## BSO

### Round end cap - pin type I

#### Systems SKO / SKO-P / SAR

We would like to inform that starting from 01.01.2017 we are introducing the new end cap **BSO/180/A** in SKO and SKO-P systems. The end cap BSO/180 which has been available in our previous offer will be available while stock lasts.

A	B	
<b>BSO/180/x</b> <sup>1)</sup>	185	190	25
<b>NEW BSO/180/A/x</b>	185	190	25

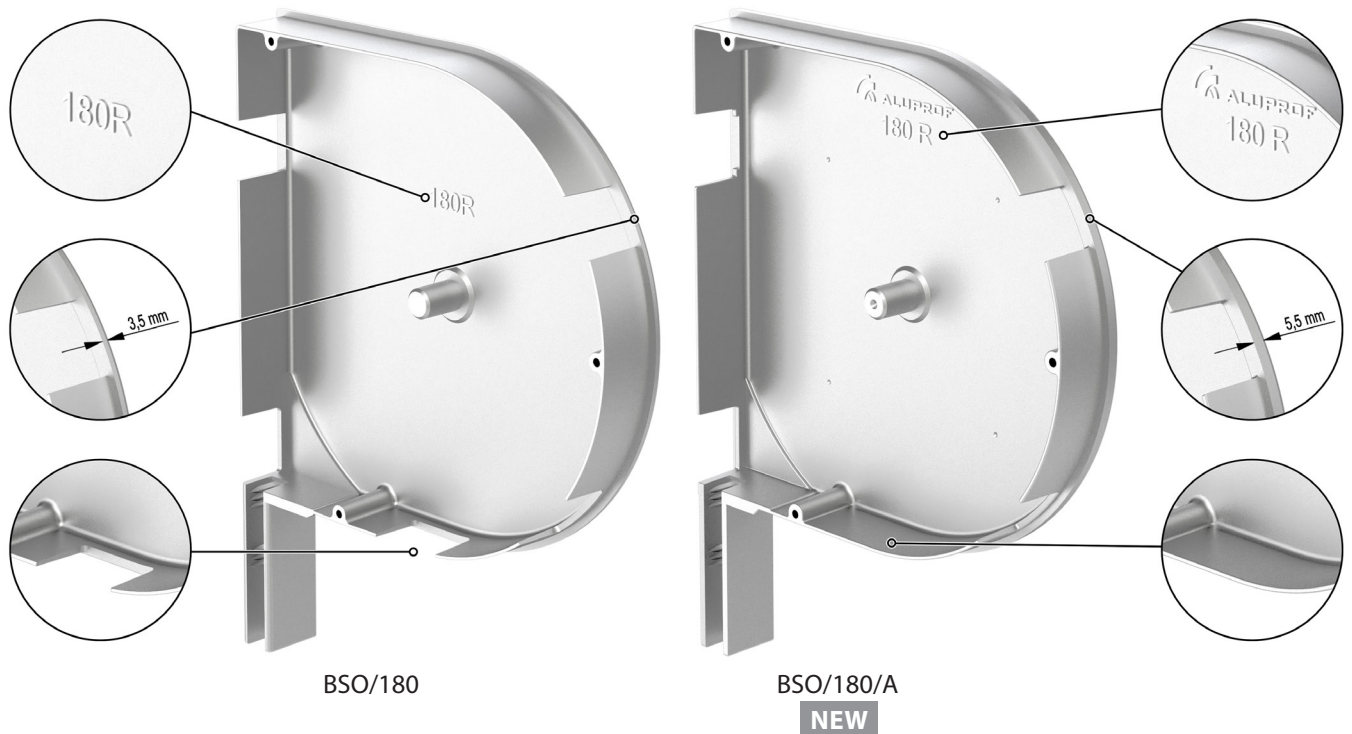
In order to facilitate the identification of individual end caps we would like to present significant differences:

Changes resulting from the increased thickness of the edge of the new cover should be taken into account when determining the cutting specification for shutter boxes.

Cutting has been standardized for all shutter box sizes.

Name of the component	Length	Quantity	SKO/180
1. Roller shutter box – top	<b>WIDTH</b> <sub>ROLLER SHUTTER</sub> – 11 mm	1 pc	SKO/G/180
2. Roller shutter box – base	<b>WIDTH</b> <sub>ROLLER SHUTTER</sub> – 11 mm	1 pc	SKO/D/180
3. Shutter box – rear	<b>WIDTH</b> <sub>ROLLER SHUTTER</sub> – 11 mm	1 pc	SKO/T/180
4. Round end cap		1 pair	BSO/180/A

Name of the component	Length	Quantity	SKO/180
1. Roller shutter box – top	<b>WIDTH</b> <sub>ROLLER SHUTTER</sub> – 7 mm	1 pc	SKO/G/180
2. Roller shutter box – base	<b>WIDTH</b> <sub>ROLLER SHUTTER</sub> – 7 mm	1 pc	SKO/D/180
3. Shutter box – rear	<b>WIDTH</b> <sub>ROLLER SHUTTER</sub> – 7 mm	1 pc	SKO/T/180
4. Round end cap		1 pair	BSO/180

Name of the component	Length	Quantity	SKO-P/180
1. Roller shutter box – top	<b>WIDTH</b> <sub>ROLLER SHUTTER</sub> – 11 mm	1 pc	SKO-P/G/180
2. Roller shutter box – base	<b>WIDTH</b> <sub>ROLLER SHUTTER</sub> – 11 mm	1 pc	SKO-P/D/180
3. Round end cap		1 pair	BSO/180/A

Name of the component	Length	Quantity	SKO-P/180
1. Roller shutter box – top	<b>WIDTH</b> <sub>ROLLER SHUTTER</sub> – 7 mm	1 pc	SKO-P/G/180
2. Roller shutter box – base	<b>WIDTH</b> <sub>ROLLER SHUTTER</sub> – 7 mm	1 pc	SKO-P/D/180
3. Round end cap		1 pair	BSO/180
